EMERALD FOREST PUD
A SINGLE FAMILY RESIDENTIAL DEVELOPMENT BY THE SITTERLE COMPANY

(POADP)
PRELIMINARY OVERALL AREA DEVELOPMENT PLAN

RE: Emerald Forest Preliminary Overall Development Plan #337

RE: Emerald Forest PUD, Units 1-5 - PUD Plan #93-002
Request for Minor Revision
Replat, Emerald Forest PUD, Unit 1: Plat #930344

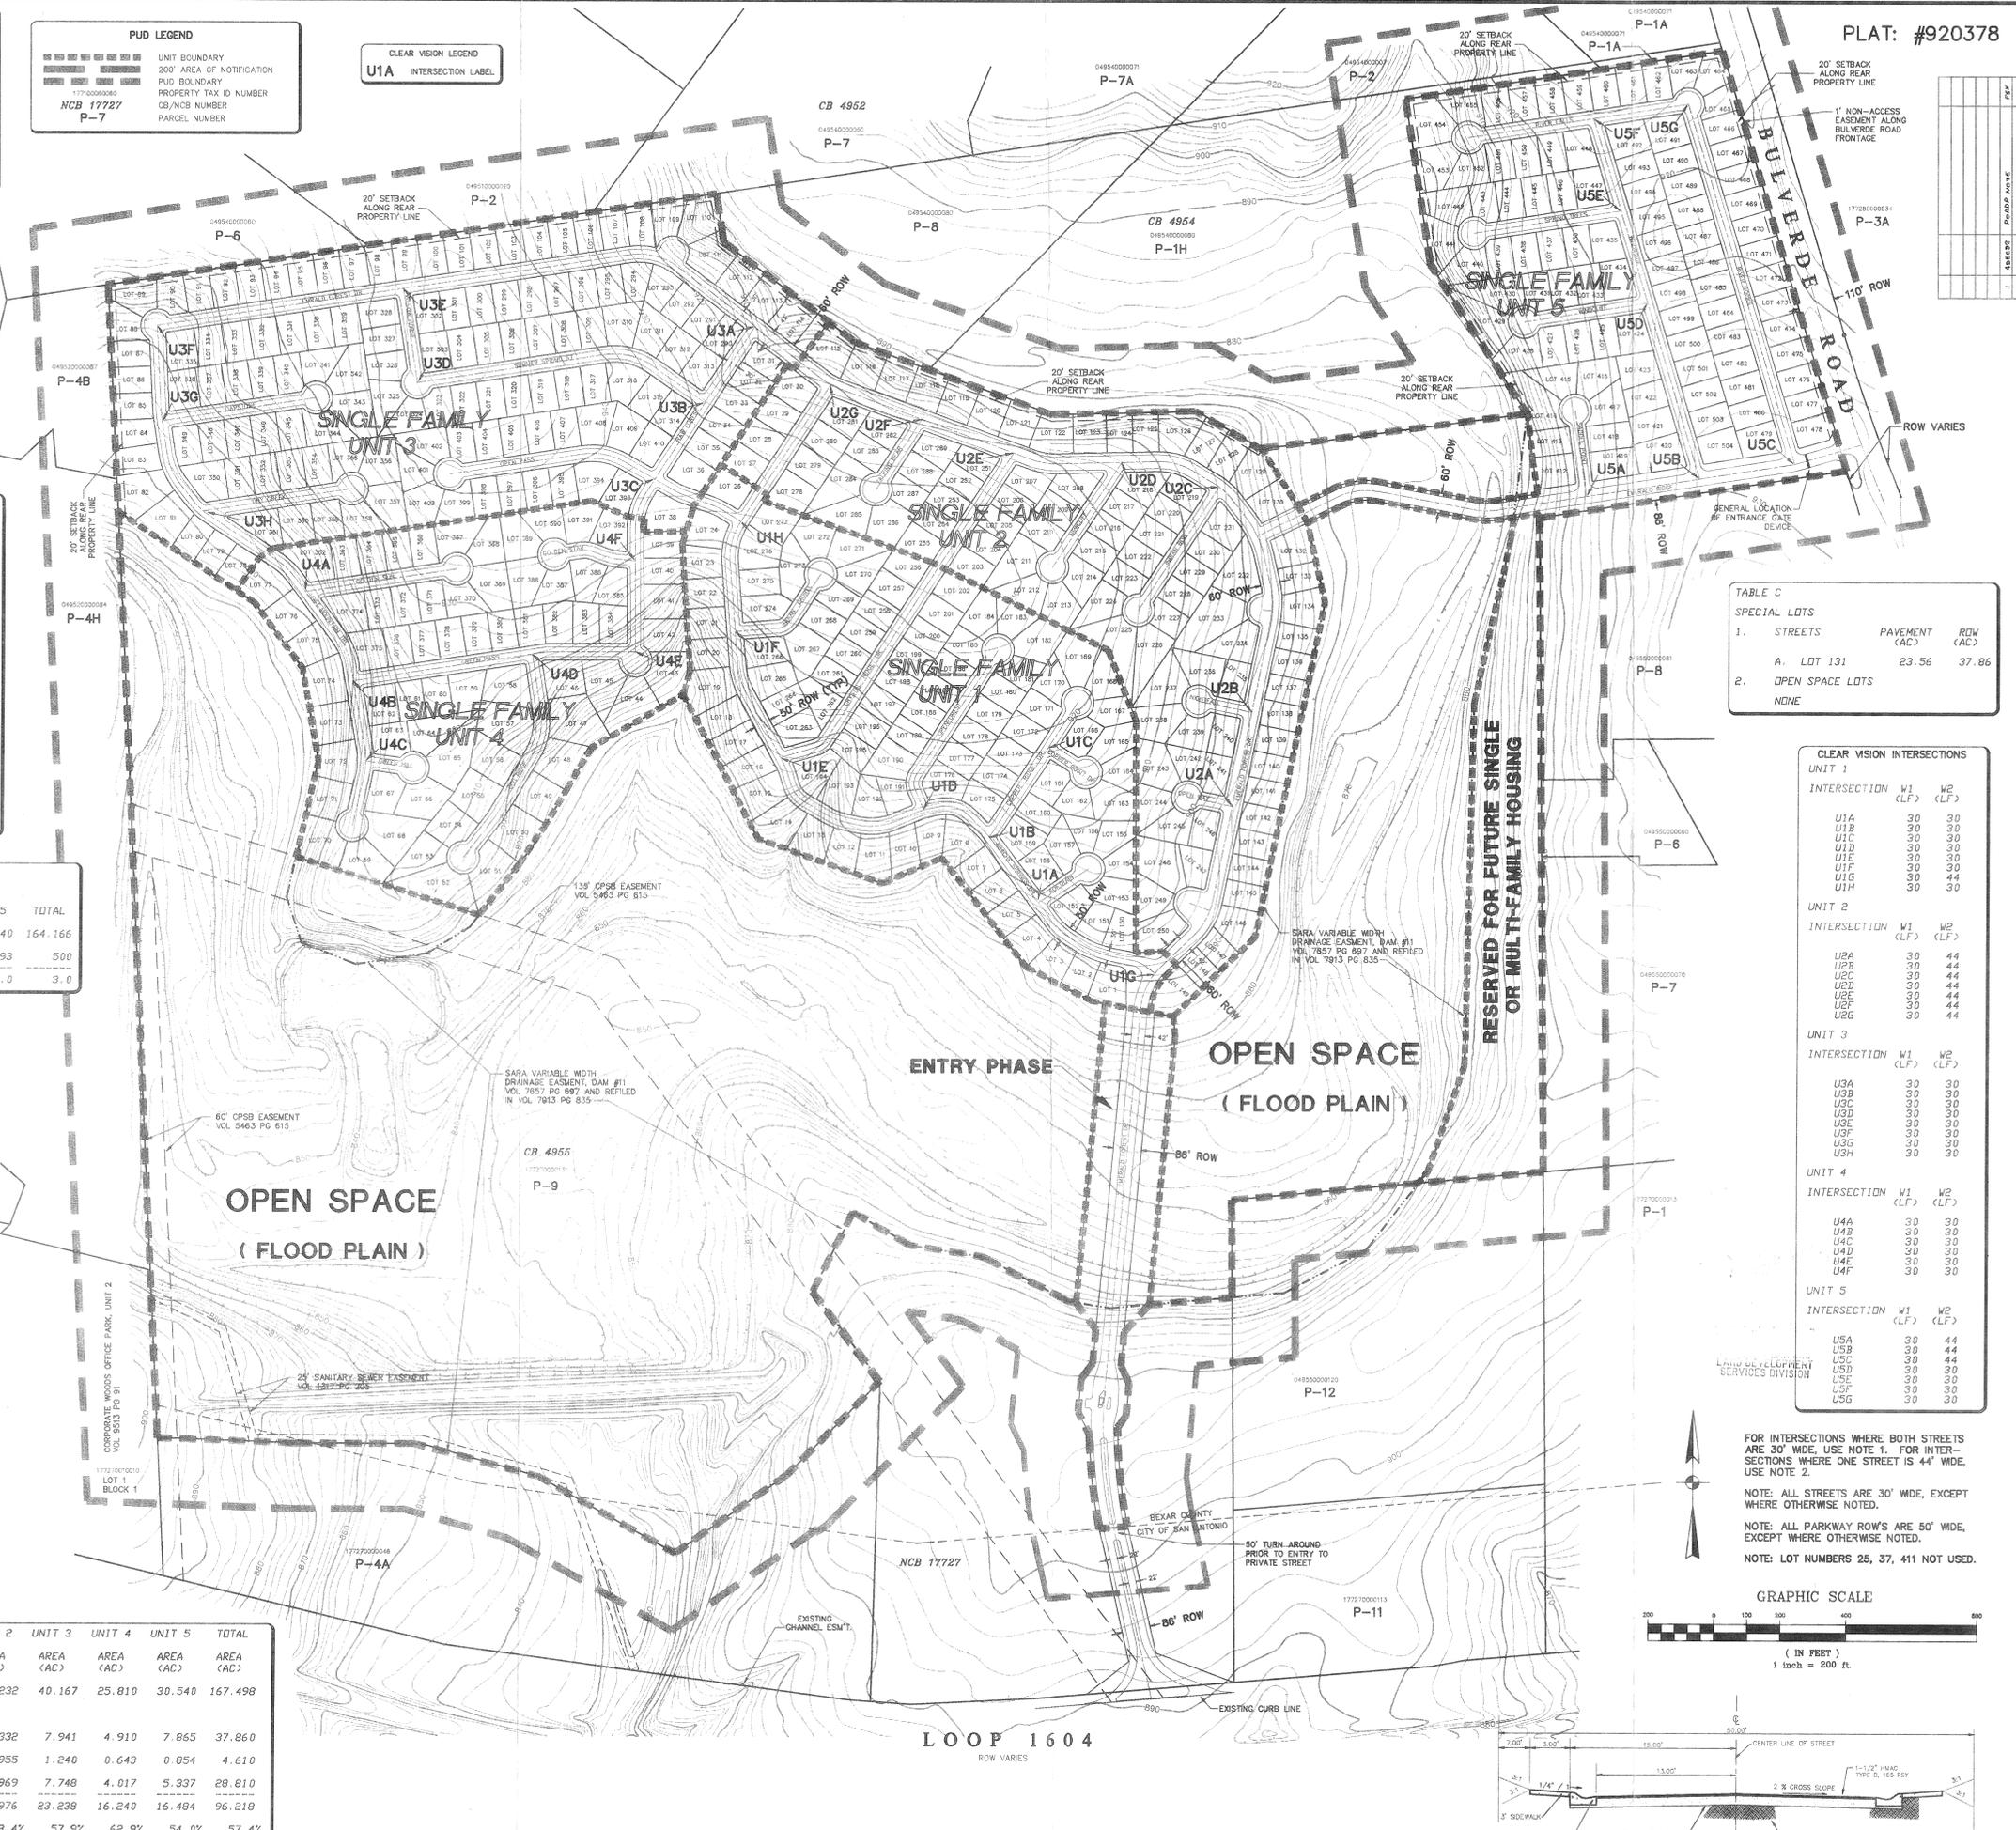
The Development Review Committee has reviewed and accepted the revised captioned POADP. However, it is recommended that consideration be given to designating the entry street at FM 1604 for private use.

The captioned plan has been reviewed for conformance with the Unified Development Code and provisions for an additional street connection between Units 4 and 1 will be required accordingly. Staff believes that, this connection will improve east-west vehicular movement as well as provide for a second outlet/inlet to this sector of the development. Please make the required change to the plan and resubmit as soon as possible.
